Process concern: risk of examination proceeding ahead of a settled evidence base (Tas Valley, water courses)

East Pye Solar (EN0110014): Deadline 1 Written Representation

White-clawed crayfish and the River Tas: request for statutory advice, and response to the Applicant's Position Statement on White-Clawed Crayfish (EXAM/8.5, EN0110014)

Ross Jolliffe, Interested Party registration [REDACTED]

River Tas 18-21 September 2026 citizen science water testing for nitrates and phosphates. Screenshots and note.

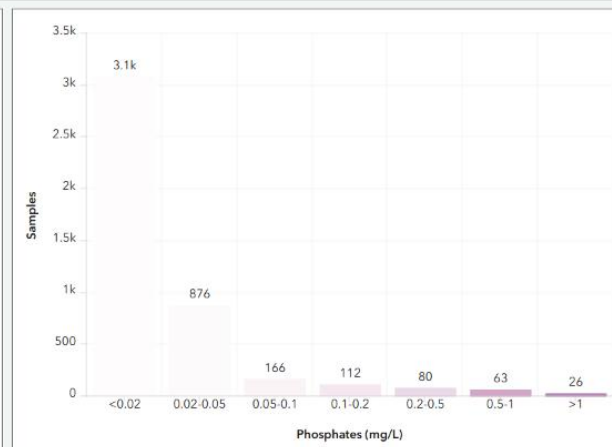
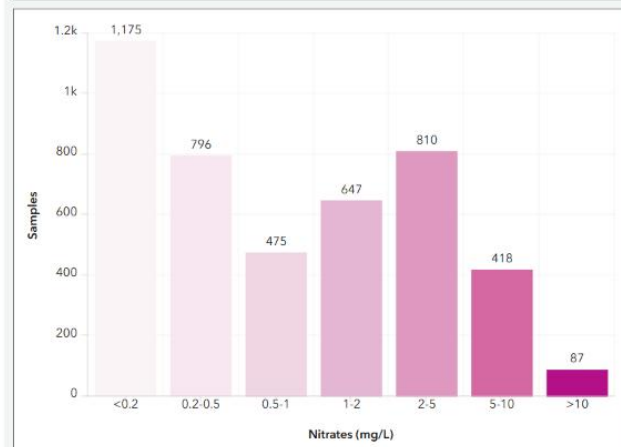
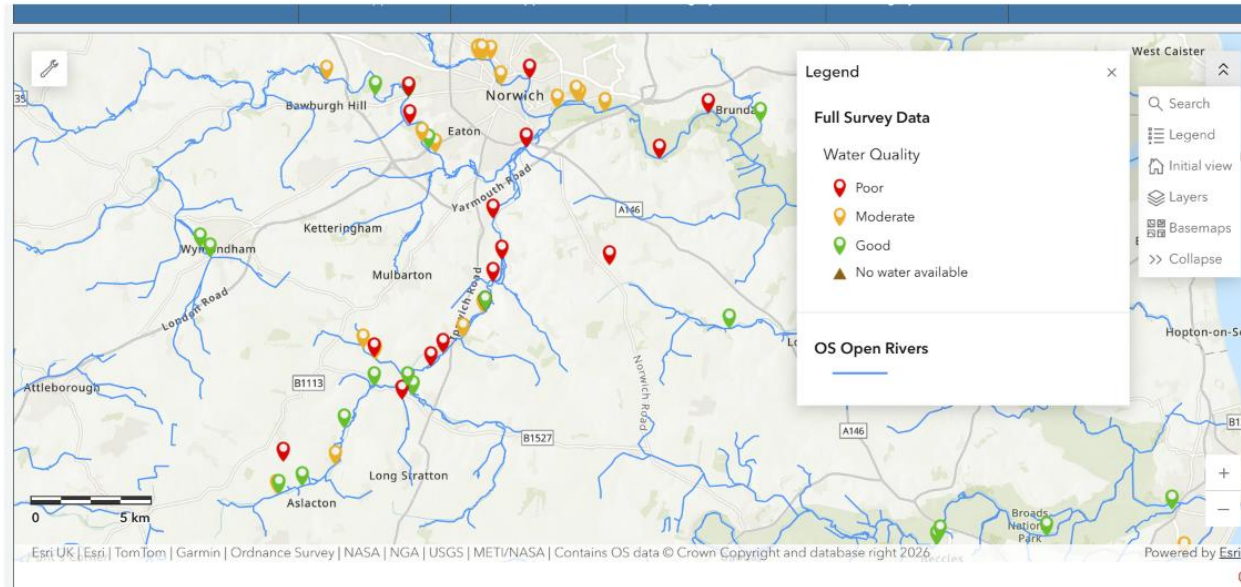
FAO east Pye Solar Examining Officer.
River Tas water quality indicator (For deadline 1).

Volunteers collected water samples along the river Tas as part of an exercise where data was collected nationally by thousands of volunteers during the Great UK WaterBlitz.

The results indicate growing agricultural inputs (nitrates) downstream and quite low sewage pollution - perhaps influenced by the 2026 dry summer, meaning Anglian Water discharges and e.g. septic tanks are less likely to be overflowing into the catchment.
